- A. New Ride-Guide Steering Cable Recommendations
- B. Merc 1500 Mid-Range Lean-Out
- C. Engine Harness Rerouting to Prevent Chaffing

B. MERC 1500 MID-RANGE LEAN-OUT

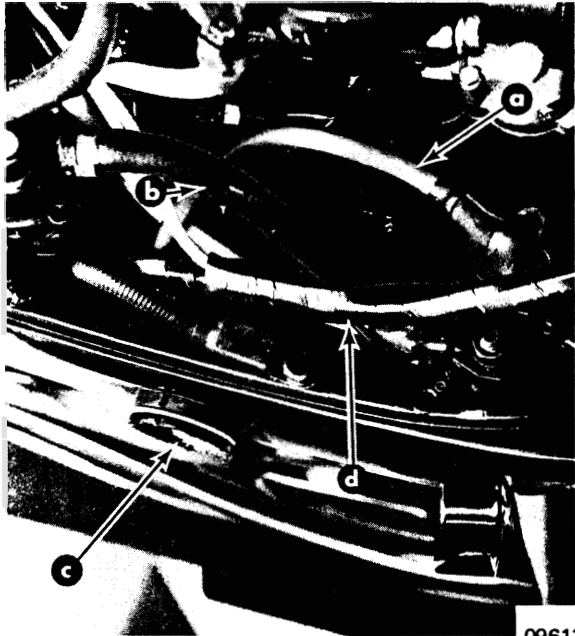
Under certain operating conditions, 1975 and early-1976 model Merc 1500 Outboards may experience mid-range lean-out.

If the outboard is operated in the 1600-2200 RPM range for several minutes, then is suddenly accelerated, it may die out. Should this happen, it usually can be corrected by turning the idle screws $\frac{1}{4}$ -to- $\frac{1}{2}$ turn counterclockwise (richer). If idle enrichment does not correct the problem, it will be necessary to remove the carburetor bowl vent jet from each carburetor.

Figure 1. Incorrect Engine Harness Routing

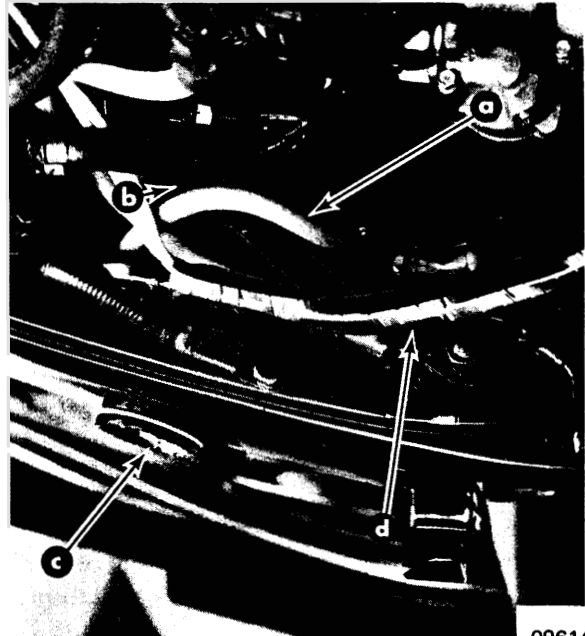
The above models may have the large, red internal engine harness wire routed between the fuel line and the cylinder block, as shown in Figure 1, which could allow the wire to chafe. To prevent this, check all units that you service and reroute the red wire as shown in Figure 2. Seal the solenoid connection with Liquid Neoprene (C-92-25111).
